## Assessment report to Sydney Central City Planning Panel

Panel reference: 2017SWC068

### Development application

<b>DA number</b>	SPP-17-00007	<b>Date of lodgement</b>	27 March 2017
<b>Applicant</b>	The Wickwood Property Group Pty Ltd		
<b>Owner</b>	R, M, E and M Haddad		
<b>Proposed development</b>	Construction of 2 residential flat buildings (8 storeys) comprising 170 apartments, 236 car parking spaces in 2 basement levels and associated civil and landscaping works		
<b>Street address</b>	Proposed Lot 1 in subdivision of Lot 74 DP208203 59 Cudgegong Road, Rouse Hill		
<b>Notification period</b>	23 July to 6 August 2018	<b>Number of submissions</b>	1 (in support)

SHEET TITLE:  
BASEMENT PLAN LVL-2

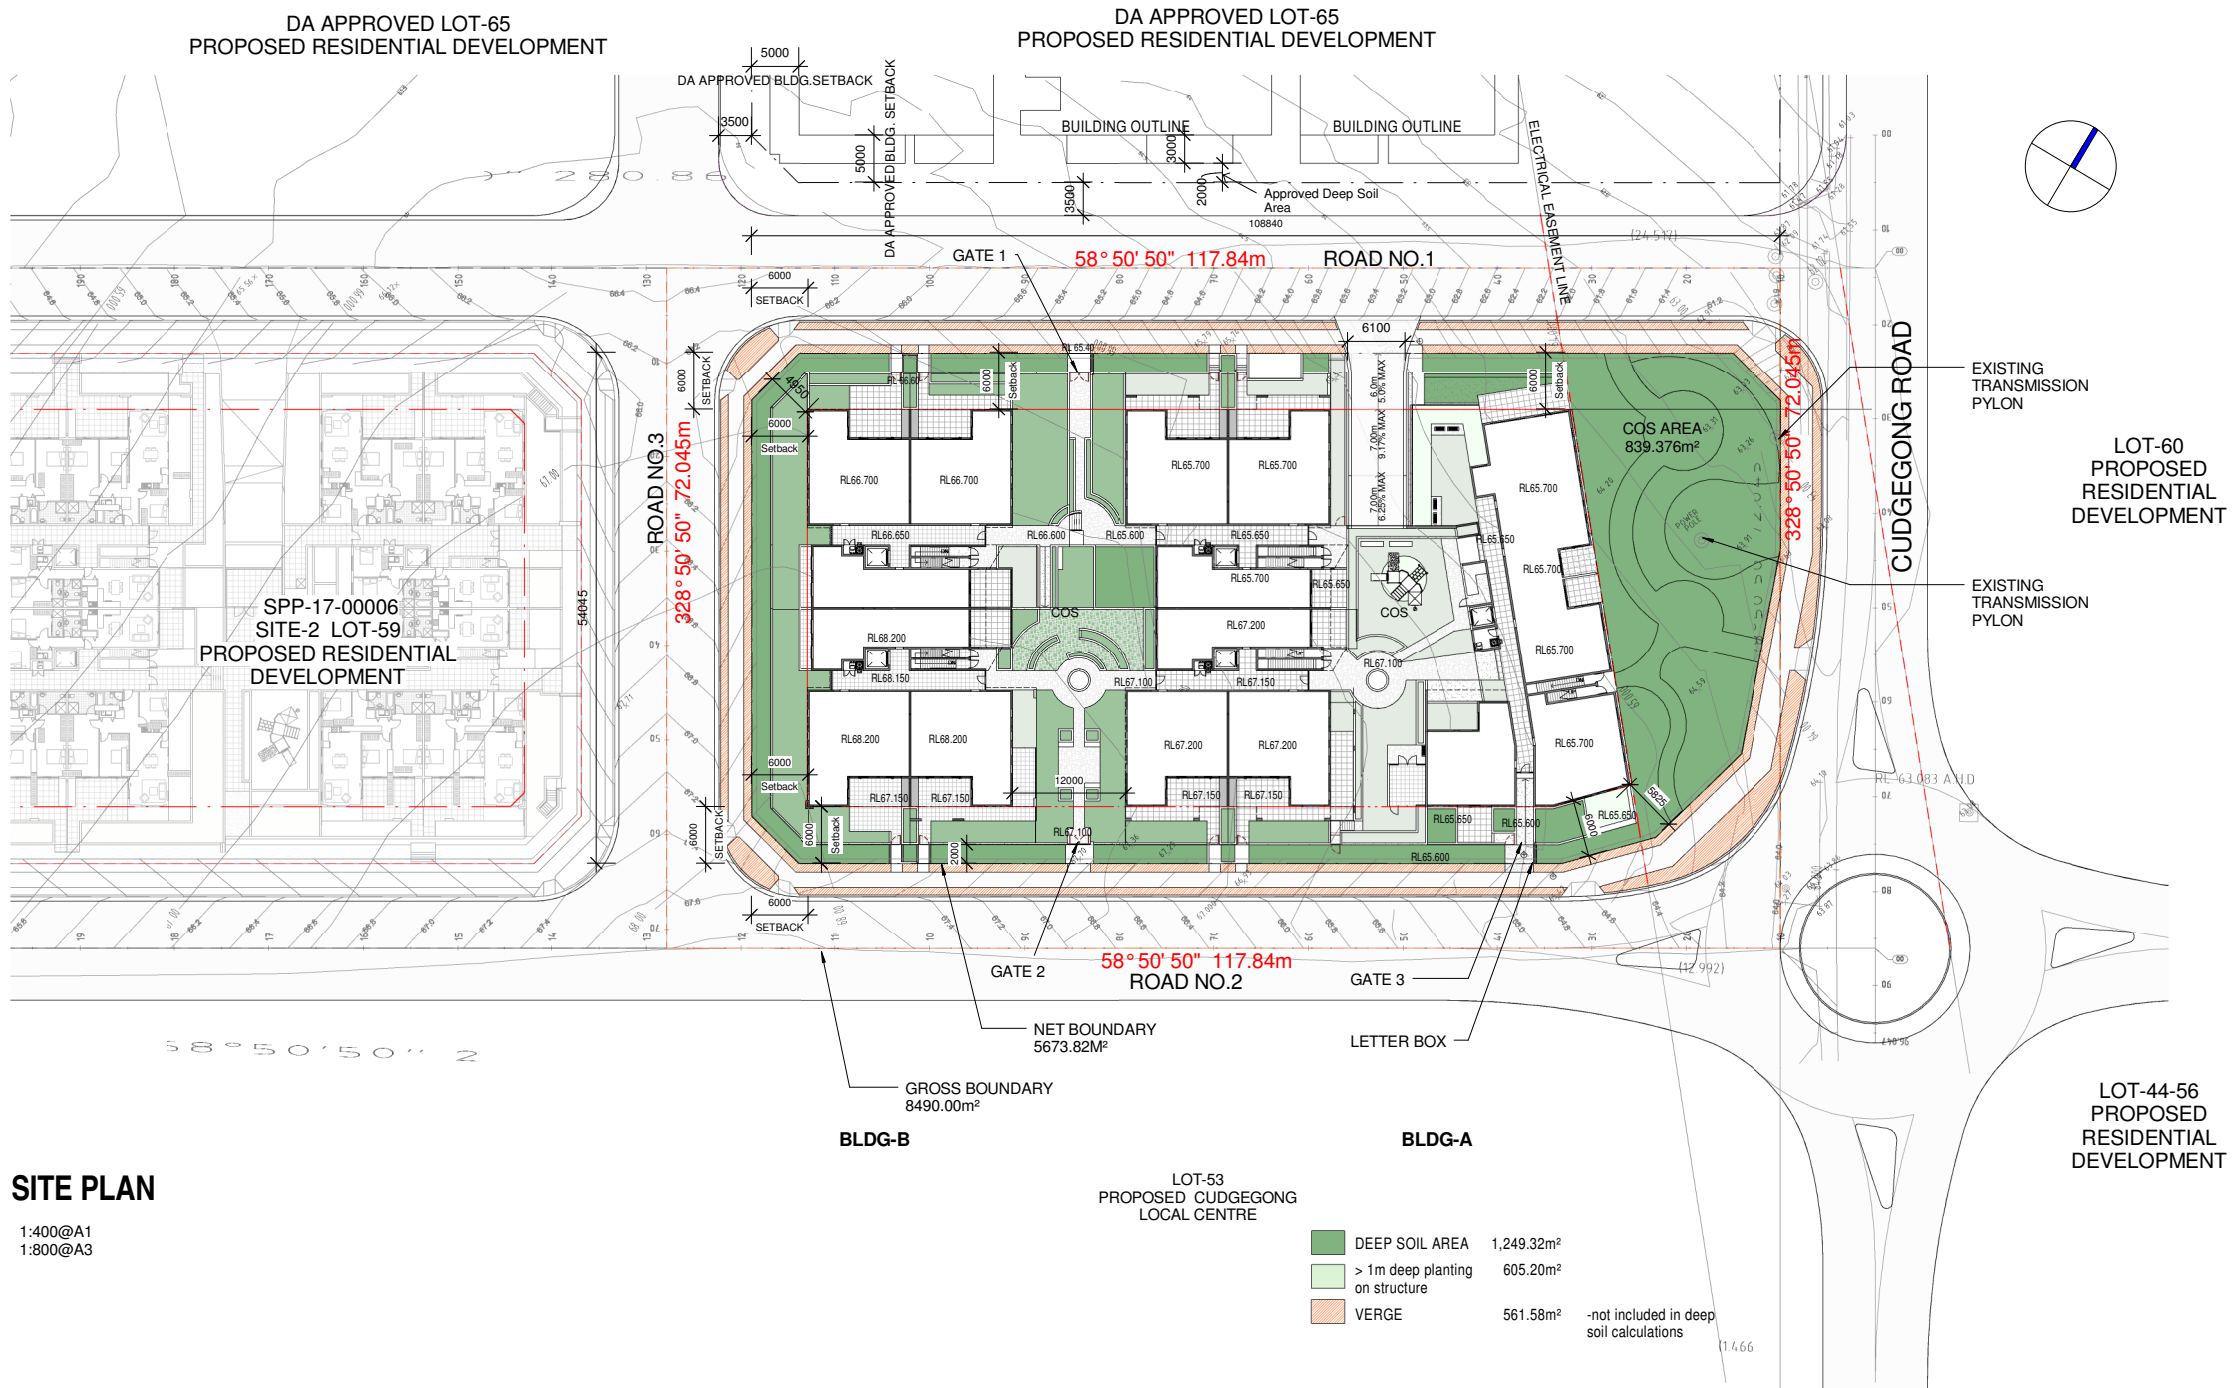
1. Bin travel path with 1.5m wide provided at basement.
2. Removable bollards and a no parking line mark noted.
3. Truck sweep paths of 11.00m long council truck provided.

4. Building-A residents access to recycling bins located at the top of the stair well and adjacent to the lift core from Level 1 and above added.
5. Waste room access adjacent to the driveway ramp relocated.

6. 1.5m wide doorway provided in each bulky waste storage areas and caged enclosure.
7. Driveway ramp gradients adjusted.
8. 240L recycling bins provided

9. Access between bulky goods and waste bin room deleted.
10. Fire stair relocated
11. Lift relocated and Waste room and bulky storage adjusted.
12. Relocate lift, fire stair adjusted and relayout of car and bicycle parkings.

DA-A203

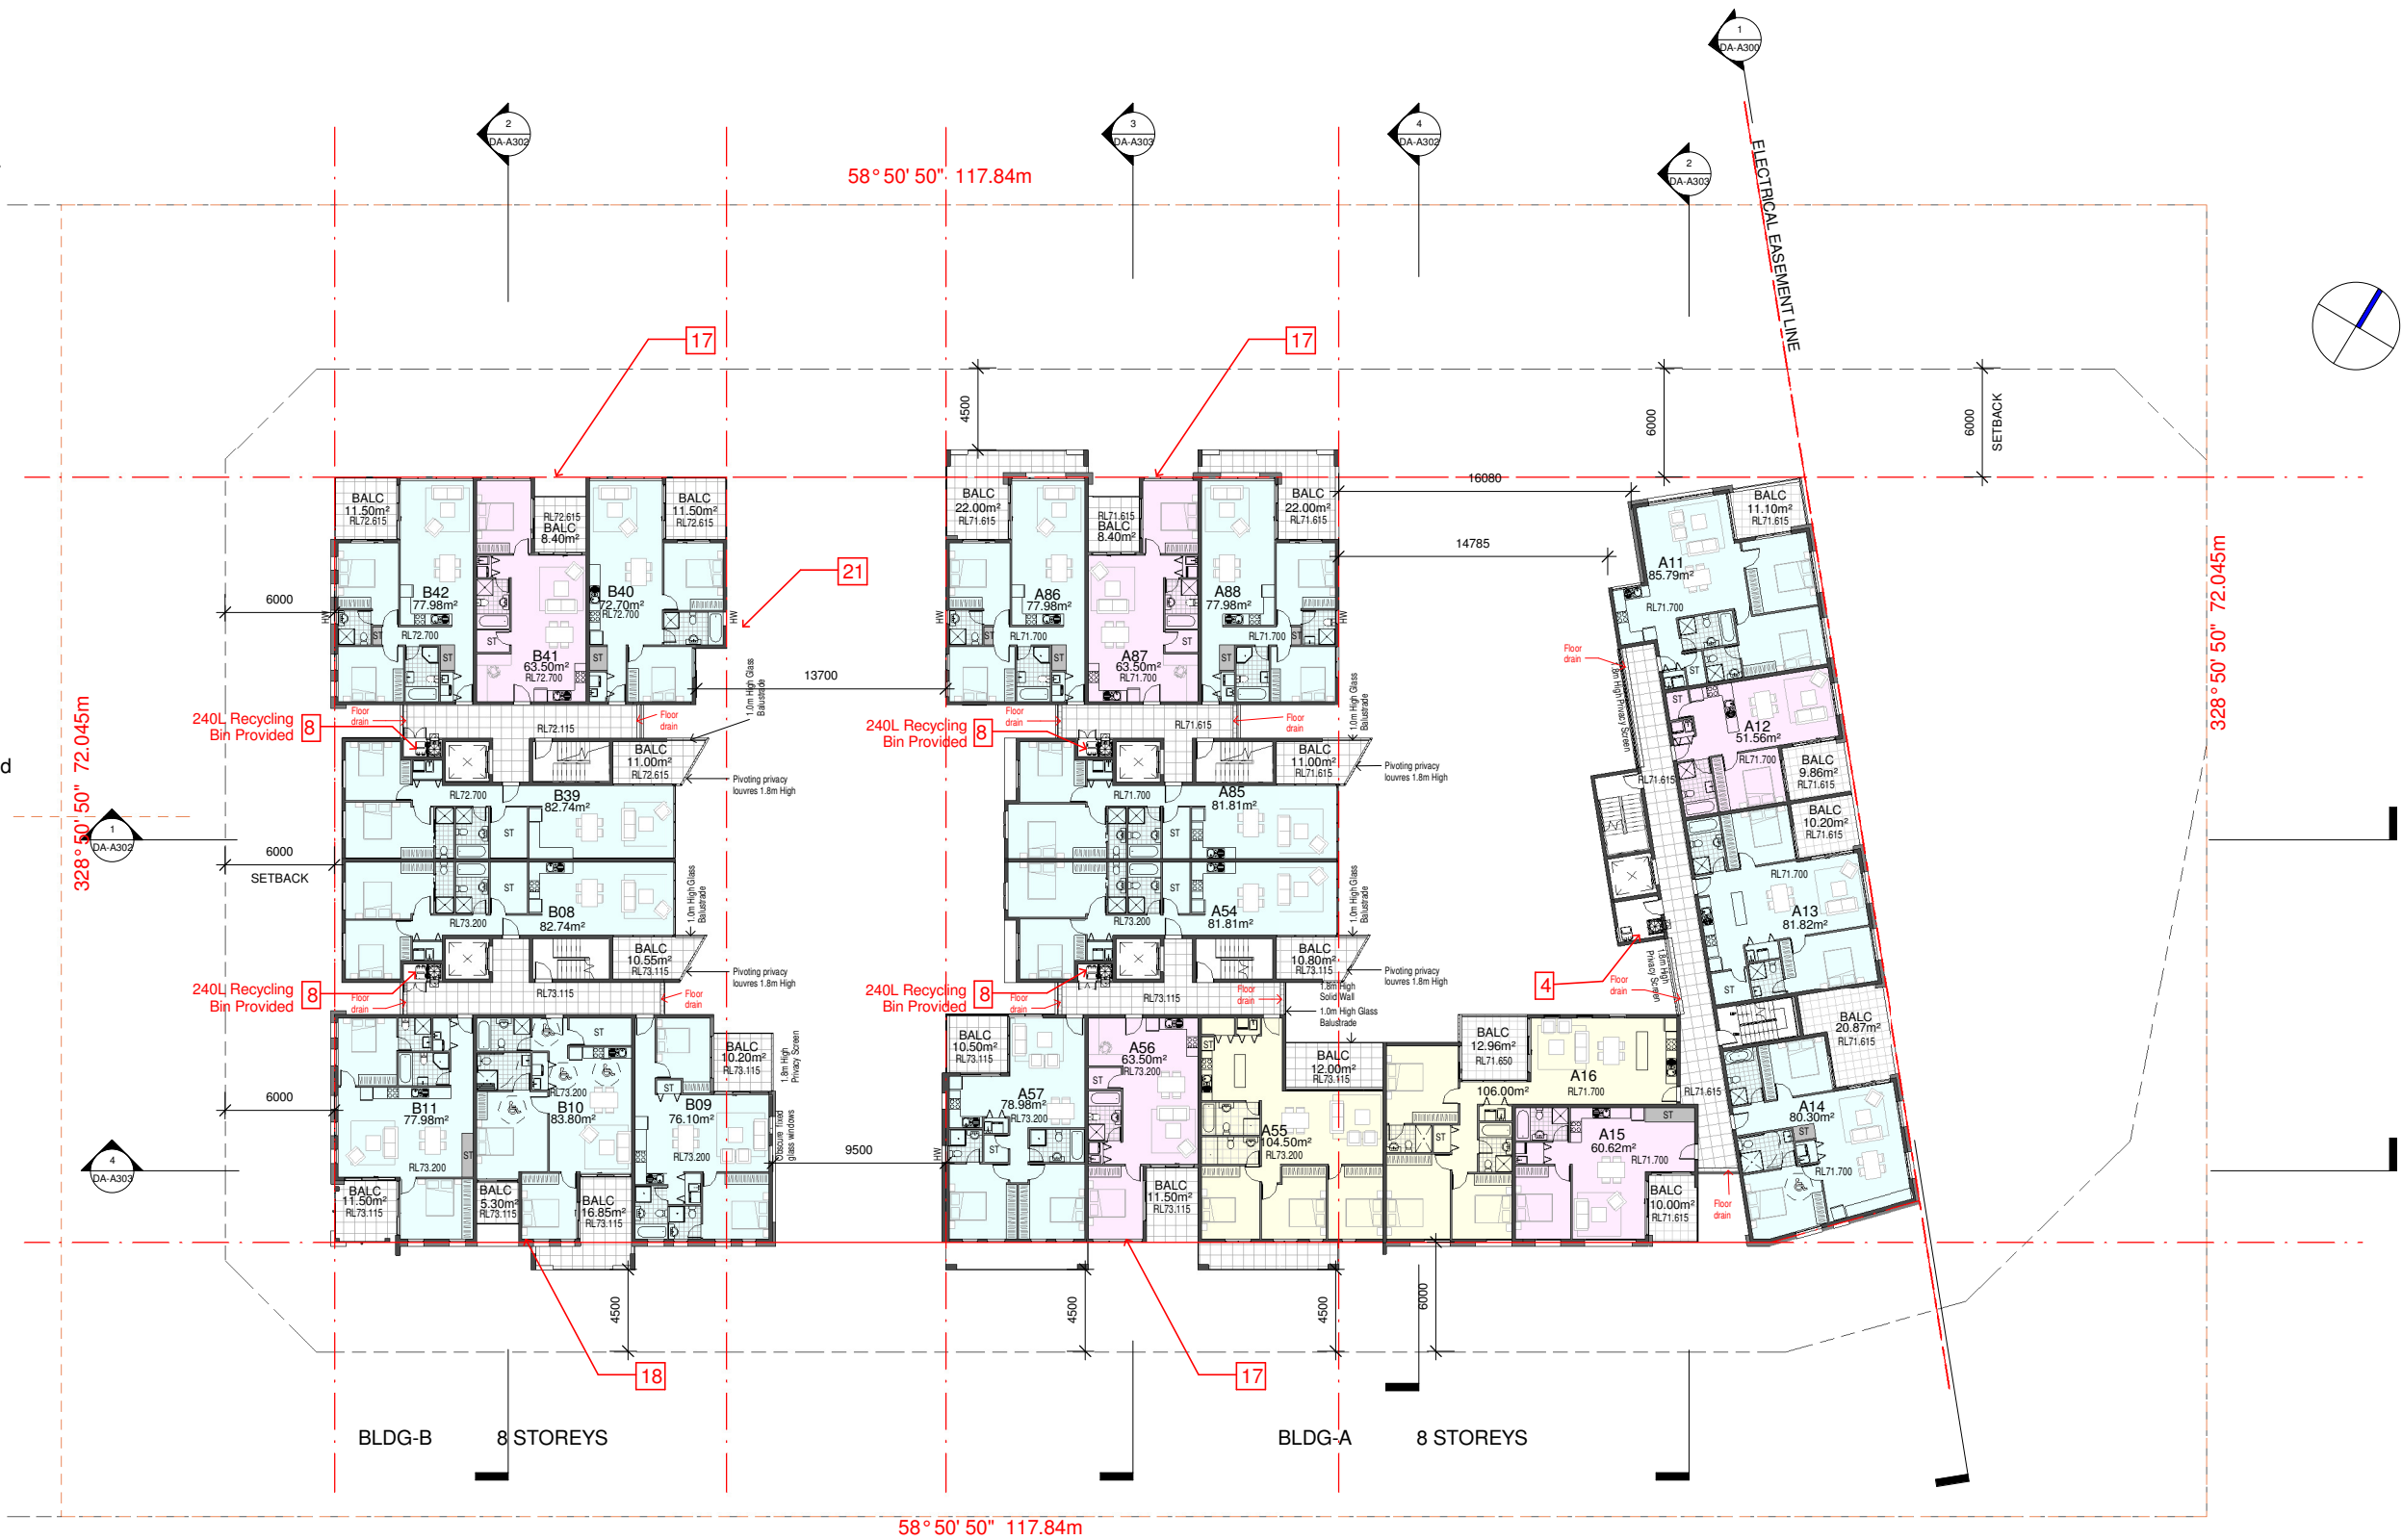
- 4.Building-A residents access to recycling bins located at the top of the stair well and adjacent to the lift core from Level 1 and above added.
- 5.Waste room access adjacent to the driveway ramp relocated.

- 16.Redesigned Building A to achieved solar access requirements to the communal open space. Fire stairs and lift relocated,access ramp added to access COS and redesigned of the unit layouts.

- 19.Building A roof plan adjusted and roof overhang deleted.
- 20.Skylights provided on Unit A45,A76,A77,B30& B31 but is not included in the solar calculation that recieved minimum 2hrs of sunlight.

ISSUE:  
F  
SHEET :  
DA-A204

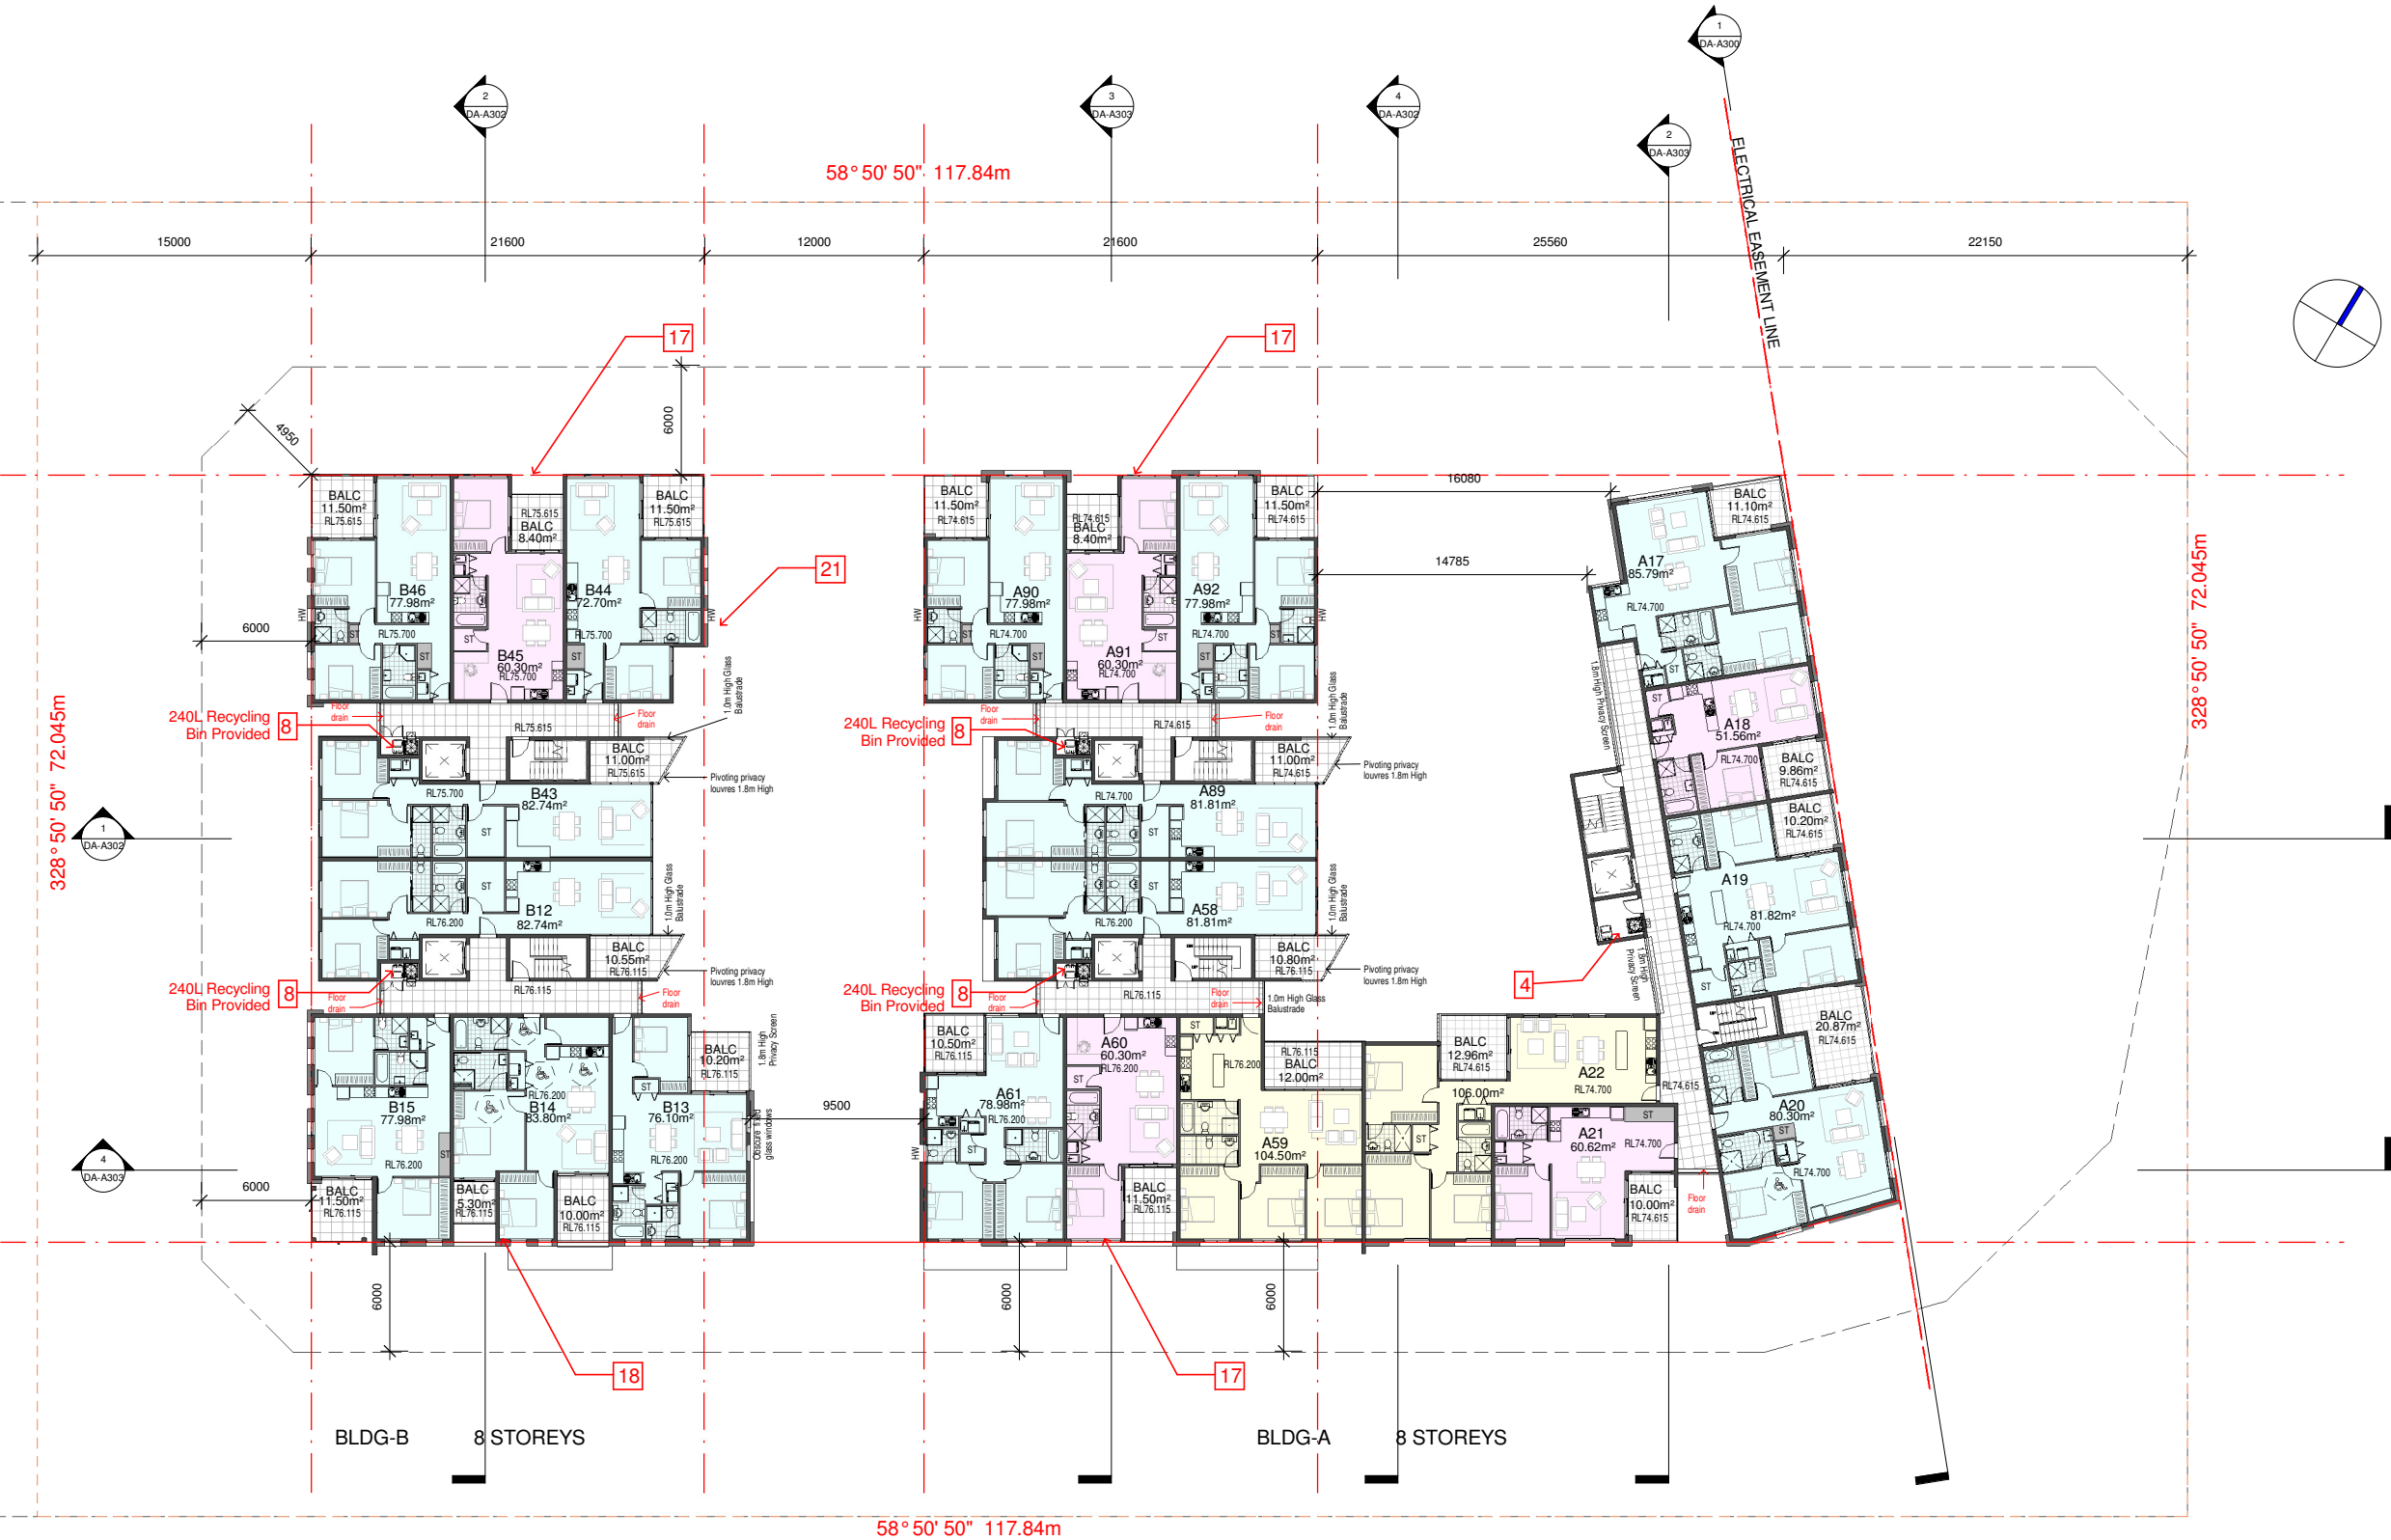
- 4.Building-A residents access to recycling bins located at the top of the stair well and adjacent to the lift core from Level 1 and above added.
- 5.Waste room access adjacent to the driveway ramp relocated.

- 16.Redesigned Building A to achieved solar access requirements to the communal open space. Fire stairs and lift relocated,access ramp added to access COS and redesigned of the unit layouts.

- 19.Building A roof plan adjusted and roof overhang deleted.
- 20.Skylights provided on Unit A45,A76,A77,B30& B31 but is not included in the solar calculation that recieved minimum 2hrs of sunlight.
